ADDENDUM:

2

PROJECT NAME: NORTHWOOD SQUARE SITE AND STORAGE

This Addendum is used to Identify Items in the Original Documents with Action as Follows:

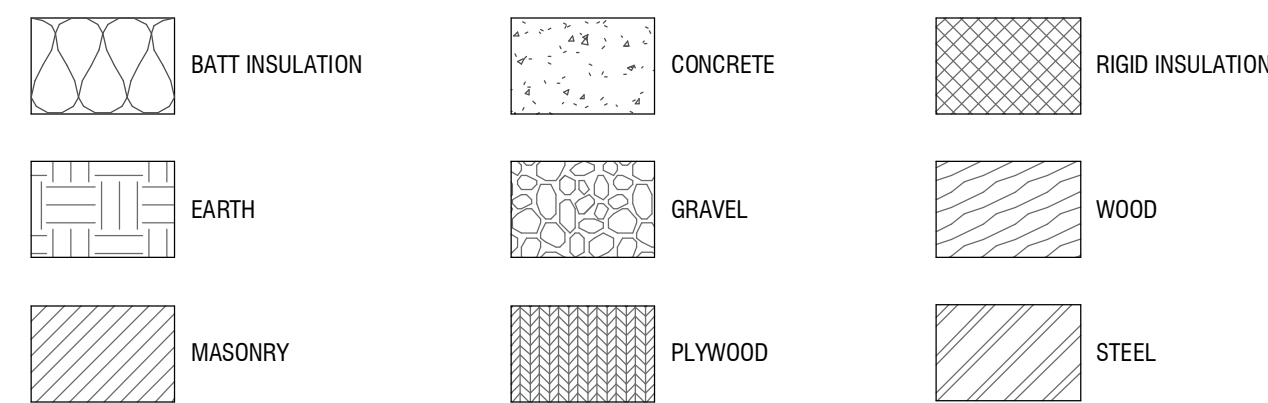
A0.0- (Revised ADA Code Reference)

Please note per 2018 IBC applicable accessible code is A117.1-2009.

Please provide details for accessible requirements per A117.1-2009 for affected features for this project to include, ramps, edge protection, handrails, locations of accessible dwelling units that may be affected, clearances for openings affected by proposed work, etc.

NORTHWOOD SQUARE
513, 529, 553, 563 8TH STREET NE
KING COUNTY HOUSING AUTHORITY
SITE PLAN AND NOTES

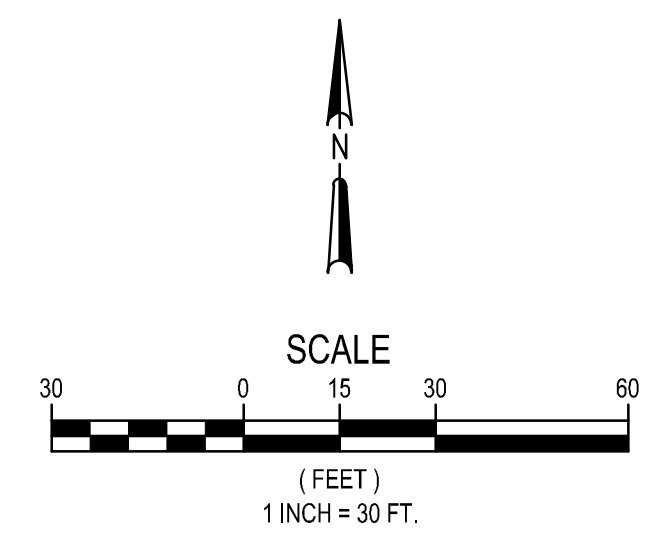
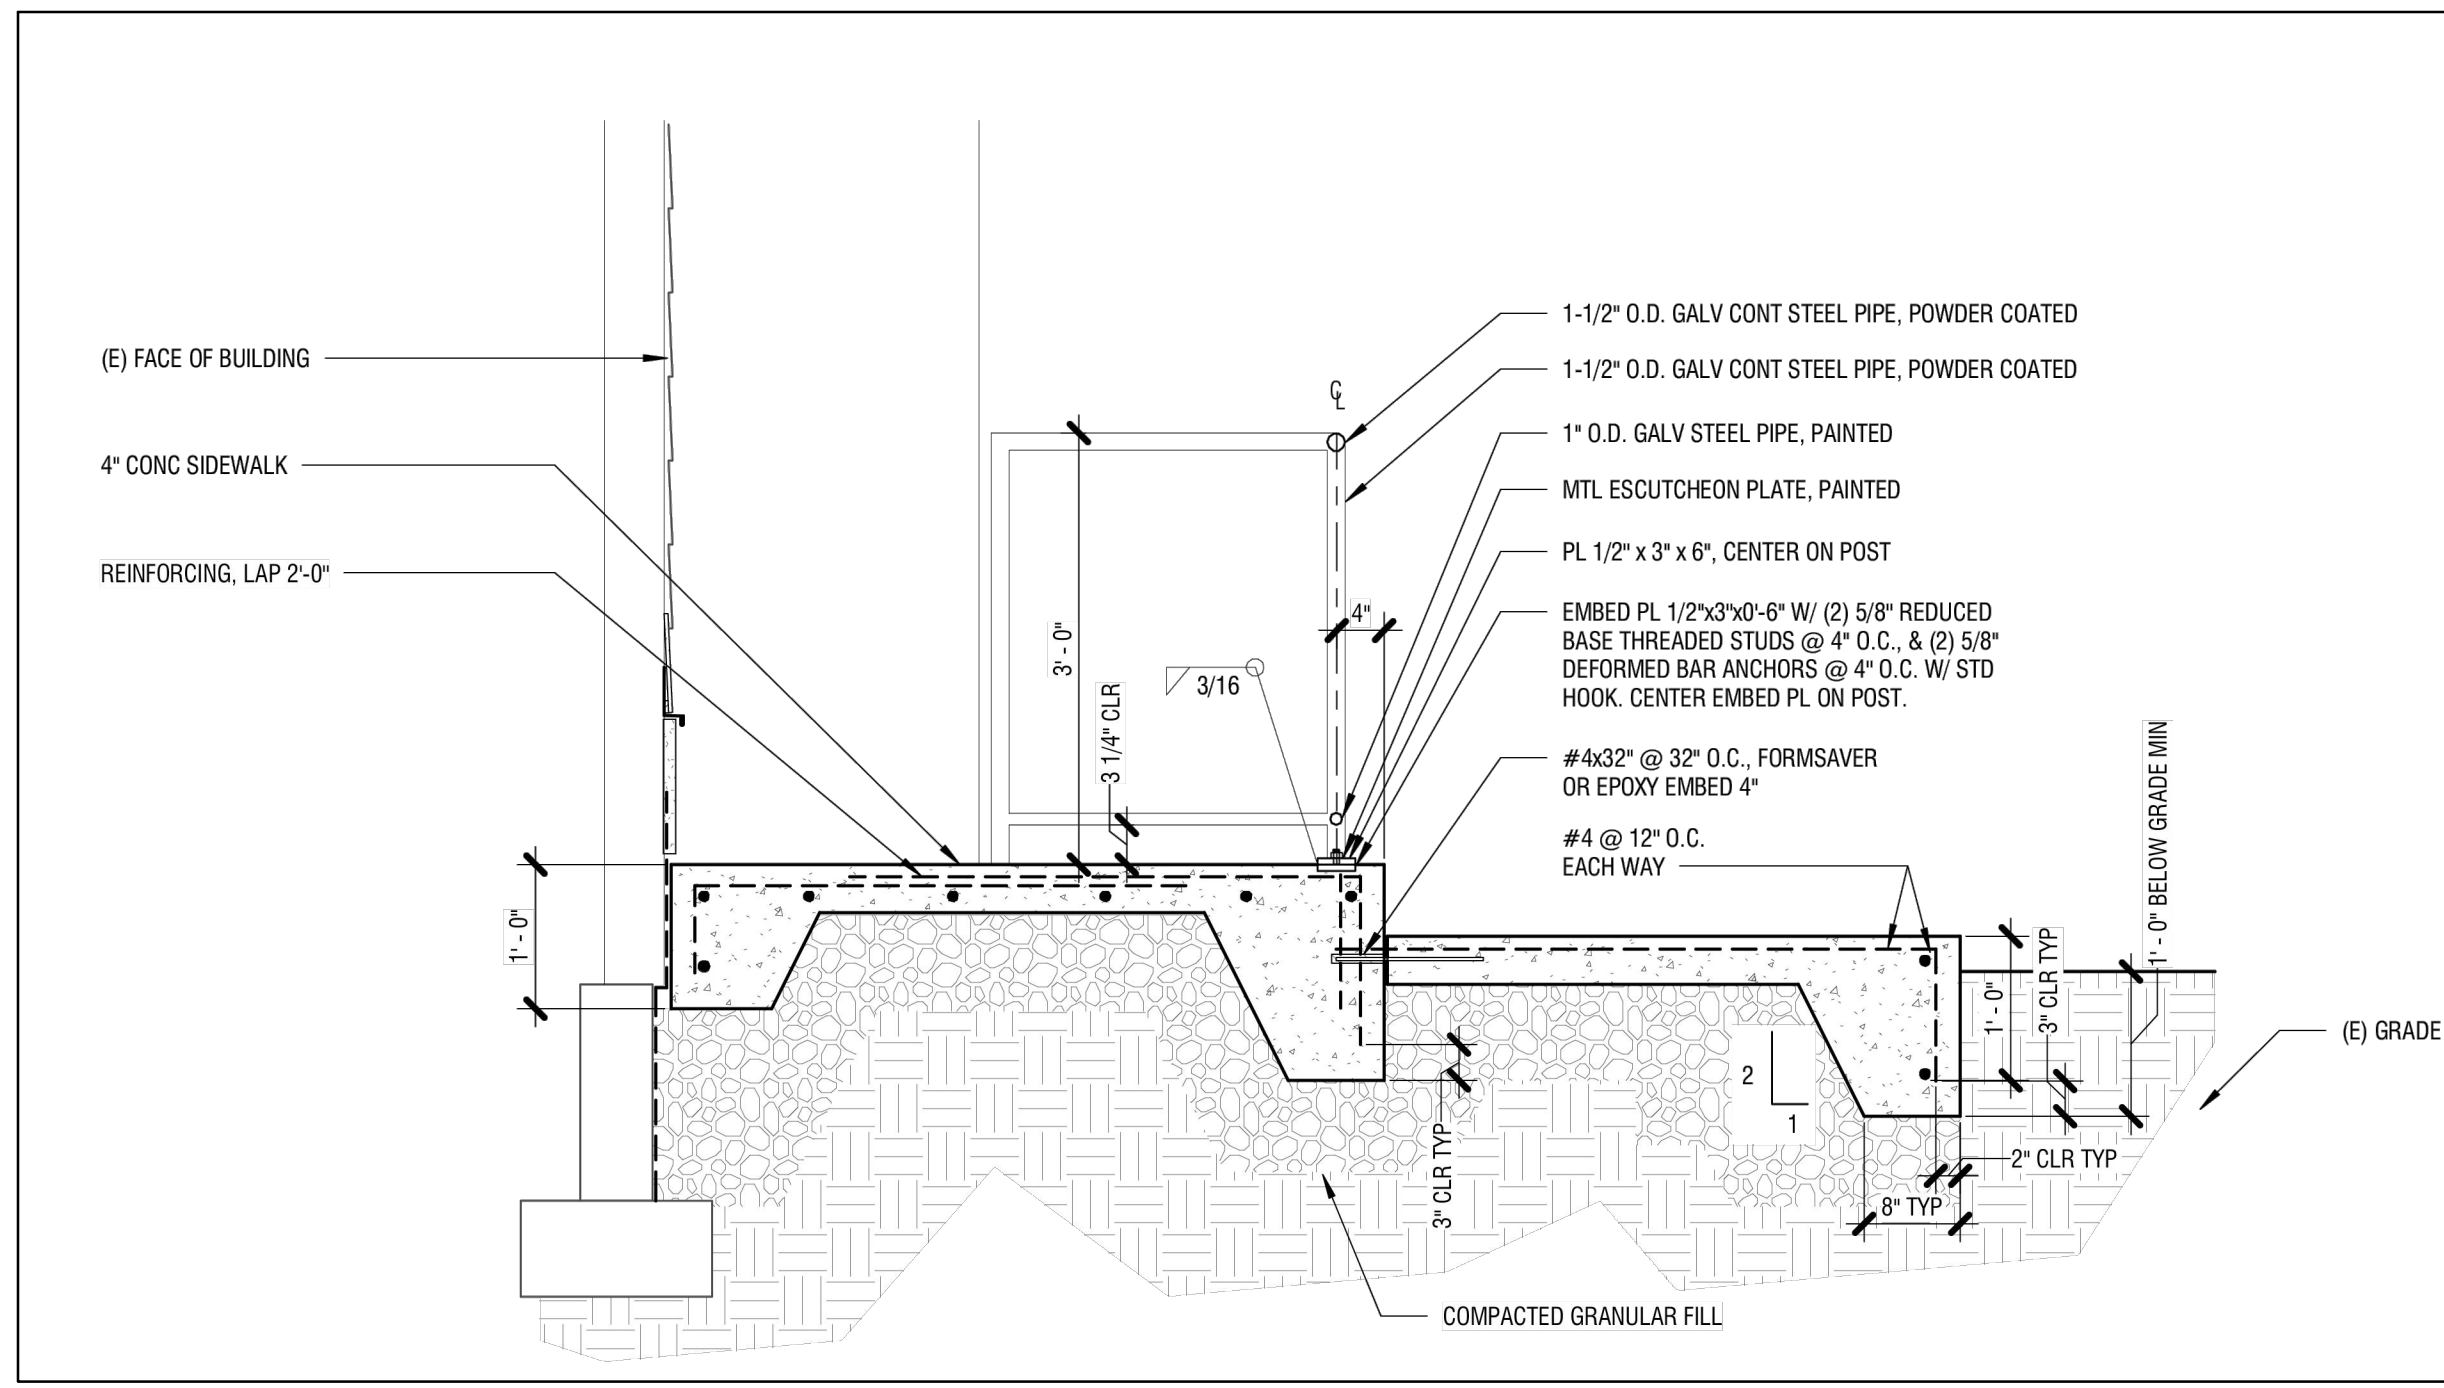
C1.0: (Revised Earthwork Quantities and Stormwater Permit Quantities and Construction Sequence)

CUT: 5 CU. YDS.
 FILL: 5 CU. YDS.
 NET IMPORT/EXPORT: 0 CU. YDS.
 TOTAL EARTHWORK: 10 CU. YDS

TOTAL DISTURBED AREA 5,074 SQ. FT.
 TOTAL NEW & REPLACED HARD SURFACE 3,355 SQ. FT.
 TOTAL NEW HARD SURFACE 0 SQ. FT.

- CONTACT THE CITY OF AUBURN AND SCHEDULE A PRE-CONSTRUCTION MEETING.
- FLAG OR FENCE CLEARING LIMITS.
- INSTALL CATCH BASIN PROTECTION IF REQUIRED, PER COA STANDARD DETAIL E-03 OR E-04.
- GRADE AND INSTALL CONSTRUCTION ENTRANCE PER COA STANDARD DETAIL E-01, IF APPLICABLE.
- INSTALL SILT FENCE PER COA STANDARD DETAIL E-02.
- MAINTAIN EROSION CONTROL MEASURES IN ACCORDANCE WITH THE CITY OF AUBURN STANDARDS AND MANUFACTURER'S RECOMMENDATIONS.
- MAINTAIN AND MODIFY EROSION CONTROL MEASURES AS SITE CONDITIONS CHANGE TO ENSURE SITE IS ALWAYS IN COMPLIANCE WITH THE CITY TESC MINIMUM REQUIREMENTS.
- UPON COMPLETION OF THE PROJECT, ALL DISTURBED AREAS MUST BE STABILIZED AND TEMPORARY EROSION AND SEDIMENT CONTROL BMPs REMOVED.

BMP T5.13: POST CONSTRUCTION SOIL QUALITY AND DEPTH

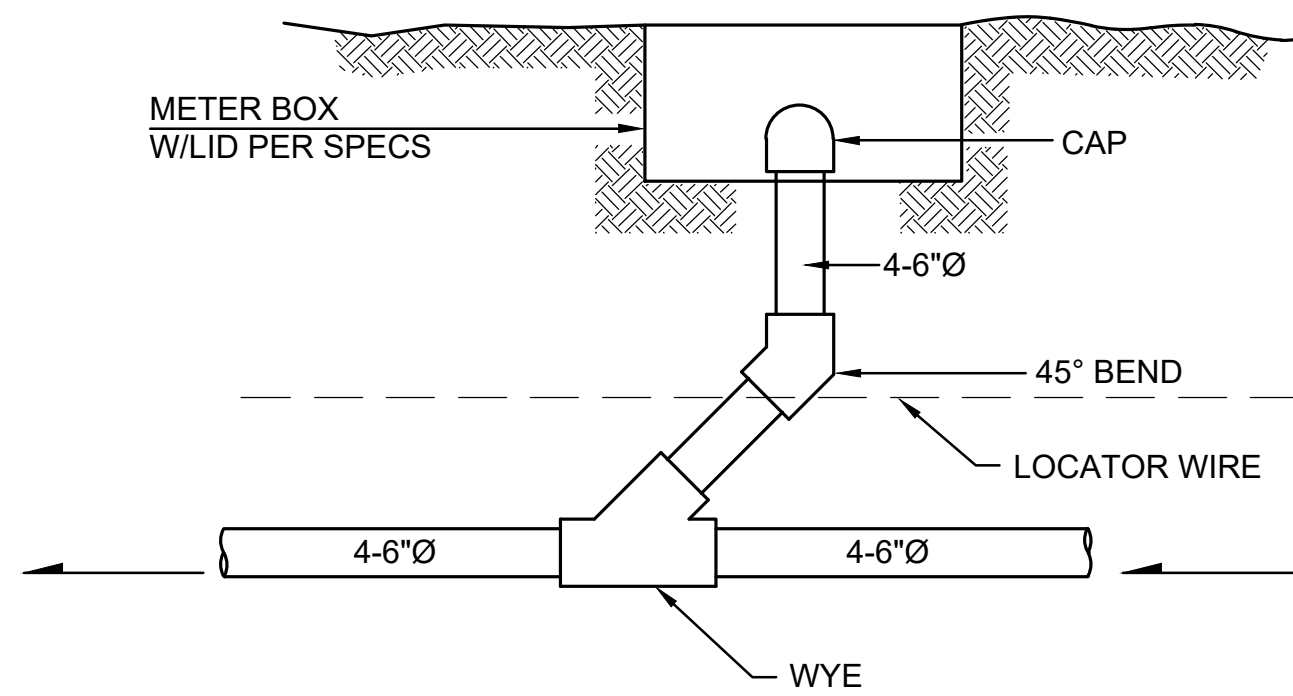
C7.0: (Added BMP T5.13 post Construction Quality and Depth Notes)

ALL AREAS SUBJECT TO CLEARING AND GRADING THAT HAVE NOT BEEN COVERED BY IMPERVIOUS SURFACE, INCORPORATED INTO A DRAINAGE FACILITY OR ENGINEERED AS STRUCTURAL FILL OR SLOPE SHALL, AT PROJECT COMPLETION, DEMONSTRATE THE FOLLOWING:

1. A TOPSOIL LAYER WITH A MINIMUM ORGANIC MATTER CONTENT OF 10% DRY WEIGHT IN PLANTING BEDS, AND 5% ORGANIC MATTER CONTENT IN TURF AREAS, AND A PH FROM 6.0 TO 8.0 OR MATCHING THE PH OF THE UNDISTURBED SOIL. THE TOPSOIL LAYER SHALL HAVE A MINIMUM DEPTH OF EIGHT INCHES EXCEPT WHERE TREE ROOTS LIMIT THE DEPTH OF INCORPORATION OF AMENDMENTS NEEDED TO MEET THE CRITERIA. SUBSOILS BELOW THE TOPSOIL LAYER SHOULD BE SCARIFIED AT LEAST 4 INCHES WITH SOME INCORPORATION OF THE UPPER MATERIAL TO AVOID STRATIFIED LAYERS, WHERE FEASIBLE.

2. MULCH PLANTING BEDS WITH 2 INCHES OF ORGANIC MATERIAL.
3. USE COMPOST AND OTHER MATERIALS THAT MEET THE FOLLOWING ORGANIC CONTENT REQUIREMENTS:
 - A. THE ORGANIC CONTENT FOR "PRE-APPROVED" AMENDMENT RATES CAN BE MET ONLY USING COMPOST MEETING THE COMPOST SPECIFICATION FOR BMP T7.30: BIORETENTION, WITH THE EXCEPTION THAT THE COMPOST MAY HAVE UP TO 35% BIOSOLIDS OR MANURE. THE COMPOST MUST ALSO HAVE AN ORGANIC MATTER CONTENT OF 40% TO 65%, AND A CARBON TO NITROGEN RATIO BELOW 25:1. THE CARBON TO NITROGEN RATIO MAY BE AS HIGH AS 35:1 FOR PLANTINGS COMPOSED ENTIRELY OF PLANTS NATIVE TO THE PUGET SOUND LOWLANDS REGION.
